BUILDING COMPLETION REPORT.

Re. Plot No. 11 B/4, Serai Qr.

PLAN SHOWING PROPOSED SHED OF

PLOT NO. II SHEET NO. B-4.

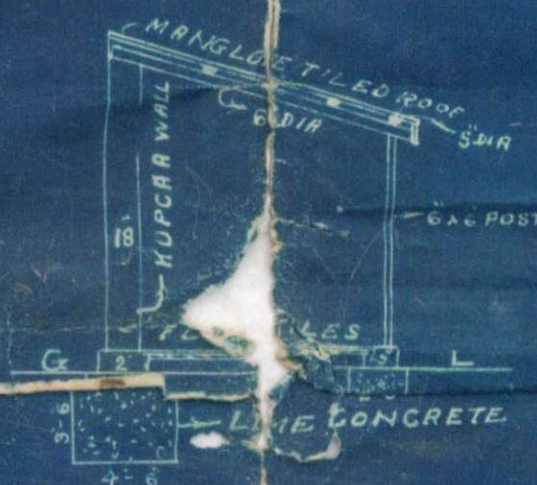
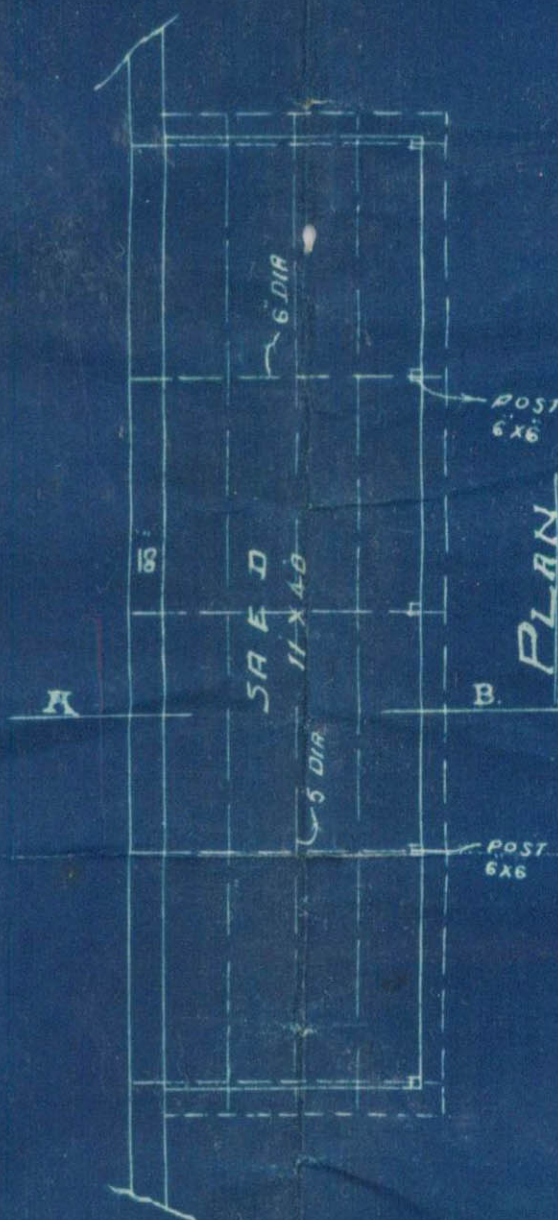
With reference to the building plan for the above plot, I have the honour to inform you that the posts provided are not ~~to the~~ according to the requirements of this office. You are therefore required to provide posts of 4"x 2" by the side of the existing posts firmly bolted together, when your plans will be approved.

With reference to his letter dated 26th April 1928 re. the above plot, Mr. C.N.Lala Architect is ~~informed~~ requested to provide 4" X 2" posts by the side of the existing posts firmly bolted to-gether after which further steps will be taken to approve the plans under reference.

The architect has been asked to provide the 4" x 2" posts
by the side of the existing 4" x 4" posts firmly bolted together

The wooden posts are 4' x 4' in size. They should be as shown on the plan.

The plans must be correctly made

As site inspected today.
The architect has complied
with the requirements by providing
4" x 2" posts along the side of the
orders requested to consider about the same for which there is no objection.
KMR
1929

Submitted to L.M.L.A. The architect has provided additional
4" x 2" post bolted down to the existing 4" x 4" posts. Orders
are requested

With reference to your letter
No 4416 of 13th inst, double posts have
been erected on site, one of 4" x 4" and
other of ~~5" x 6"~~ ^{and bolt them together to make the posts 6" x 4"} and the same are shown
on the plan.
